SI/Hunter/135

A SI/HUNTER/135A  
 (SUPERSEDING SI/HUNTER/126D)  
 FIN REAR ATTACHMENT FITTINGS, CRACKING.

B 1 Hunter, all marks.

FIG 1  
SI/HUNTER/135

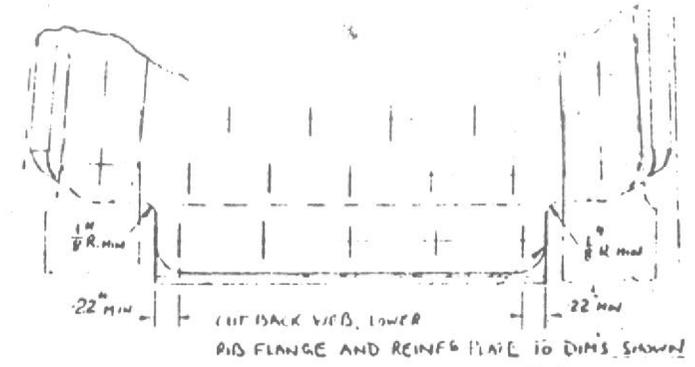
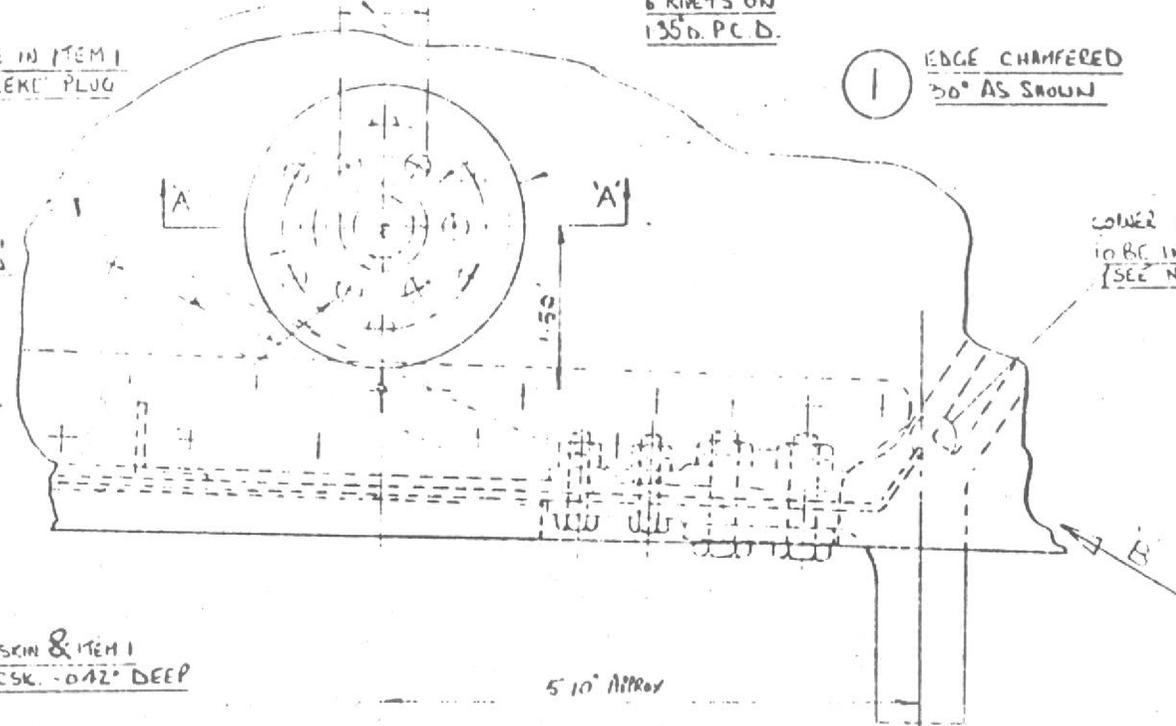
(1) Introduce inspection holes and reinforcing plates port  
 and starboard IAW HSA Sketch No E.44312 attached as Fig 1.

(2) Cut back web lower rib flange and reinforcing plate,  
 if required, to gain access for NDT examination. Scrap view on  
 sketch B.44312 refers.

CORNER OF REAR ATTACHMENT FITTING TO BE INSPECTED PORT & STBD. (SEE NOTE 1)

1. ACCESS HOLES ARE REQUIRED PORT & STBD SIDES FOR ENDSCOPE INSPECTION OF CORNERS OF REAR ATTACHMENT FITTINGS
2. NO ADHESIVE TO BE USED TO RETAIN CHEKALEKE PLUG.
3. FOR ALL FURTHER DETAILS SEE DRG. NO. D.281863

27/32" DIA HOLE IN ITEM 1 FOR CHEKALEKE PLUG

DRILL HOLE IN SKIN & ITEM 1  
1.28" - 1.51" DIA. CSK. - 0.42" DEEP  
IN ITEM 1
